UNITED STATES PATENT AND TRADEMARK OFFICE

10/789,610

Office Action Summary	Application No. 10/789,610	Applicant(s) LIM, ROY K.	
	Examiner John Kim	Art Unit 3733

DETAILED ACTION

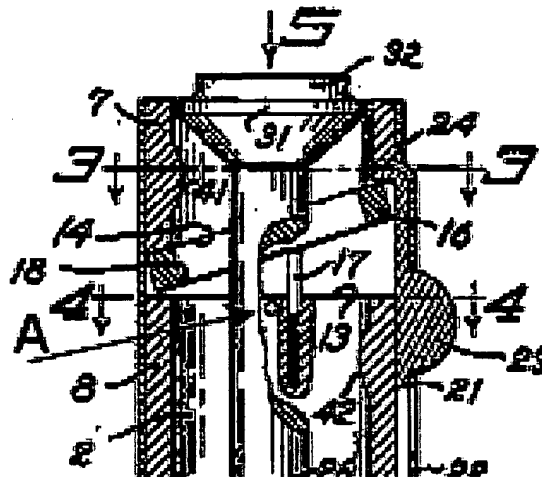
In regards to claim 38, Krafft has a plate (18) with two edges and an aperture, a shaft (21, 23) which is connected to the plate at one edge (near 16) and can pivot the plate around the second edge (near 18). The plate moves between two positions (figures 1 and 2) where figure 2 shows the plate in the "locked" position. In regards to claims 39 and 40, Krafft discloses having a sleeve (7), which is slidable with respect to the shaft, and the sleeve has an end portion which is able to contact a spinal rod. As discussed above and in reference to claim 41, Krafft discloses having a ratchet mechanism (17), where the coils of the spring are the teeth of a bar and a pin (A, see figure above) is the pawl.
